SERVICE BULLETIN

Inspection, Check and Replacement of Hook
Assembly P/Ns 505960-401 and 502737-459

ATA 25-20-01 and 25-10-01

SB505960-01, Issue: 5
Page: 1 of 13
Date: 06-Aug-2018

Figure 1 – Hook Assembly Without Exposed Springs

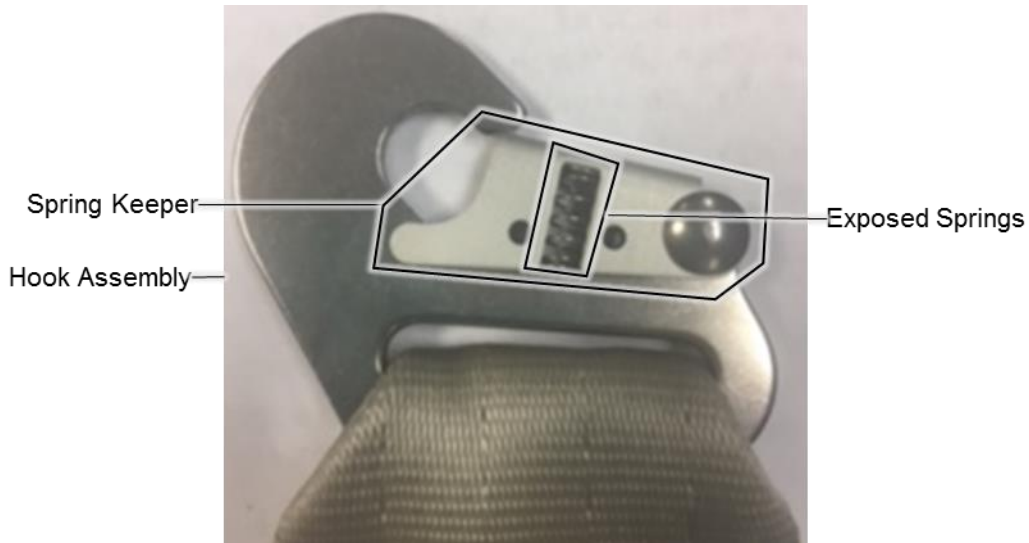
RC Step 3. Find the hook assembly (Figure 1 and Figure 2) on the connector half and the buckle half.

Step a. If the hook assembly on the connector half and the buckle half does not have exposed springs (Figure 1) you are done with this service bulletin.

Step b. If the hook assembly has exposed springs (Figure 2) proceed with this service bulletin.

Hook assemblies with exposed springs are subject to damage (e.g. compressed springs, bends, rotation or deformation).

Restraints without exposed springs (Figure 1) weigh 6 grams more than restraints with exposed springs (Figure 2).

This service bulletin ensures hook assemblies do not have exposed springs by providing the criteria and instruction to identify and replace restraints.

Figure 3 – Damaged Hook Assembly

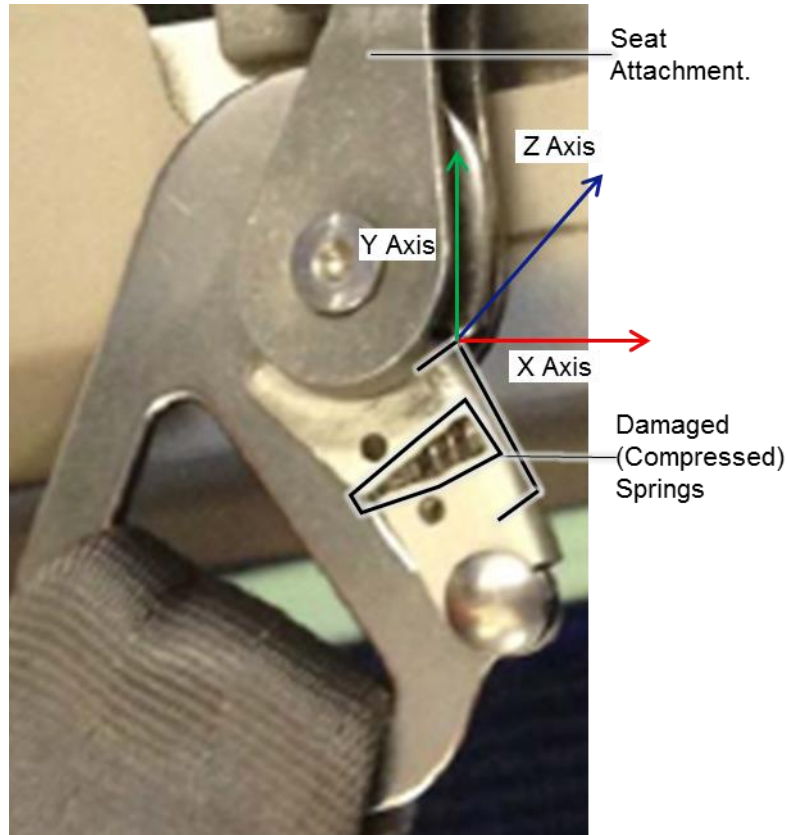
RC Step 2. Visually examine the hook assembly for damage (e.g., compressed springs, bends, rotation or deformation of the bridge along the X axis, Y axis or Z axis) that would restrict movement or function (Figure 3 and Figure 4).

Step a. If there is no evidence of damage the visual inspection is complete. Perform a functional check following the procedure in section 3.3.

Step b. If there is evidence of damage a functional check is not required.

Step i. Return the restraint to AmSafe by following the instructions in section 2.1 and by following the shipping and handling instructions in the ICA or CMM.

Step ii. Upon receipt of a new restraint from AmSafe, install the new restraint following the instructions in the ICA or CMM.

Figure 5 – Spring Keeper and Closed Loop

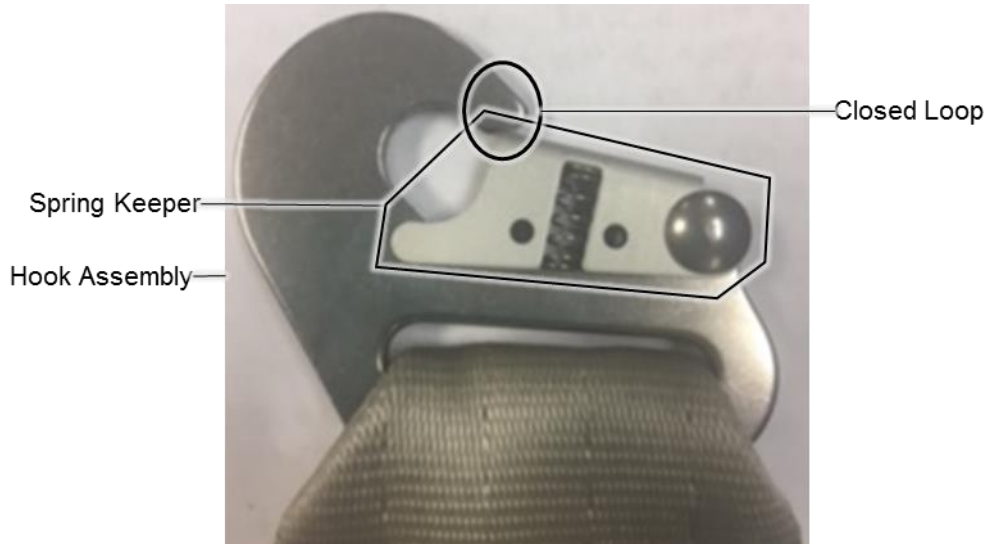
Step b. The spring keeper should return to a closed position. The closed position is achieved when the spring is firmly engaged/pressed and the keeper is against the hook, creating “closed loop” (Figure 5). There should be no deformation or damage preventing the spring keeper from returning to a closed position.

- Step c. If the spring keeper easily compresses and releases and returns to the closed position the functional check is complete.
- Step d. If the spring keeper does not easily compress and release, or the spring keeper does not return to a closed position, return the restraint to AmSafe.
- Step i. Return the restraint to AmSafe by following the instructions in section 2.1 and by following the shipping and handling instructions in the ICA or CMM.
- Step ii. Upon receipt of a new restraint from AmSafe, install the new restraint following the instructions in the ICA or CMM.
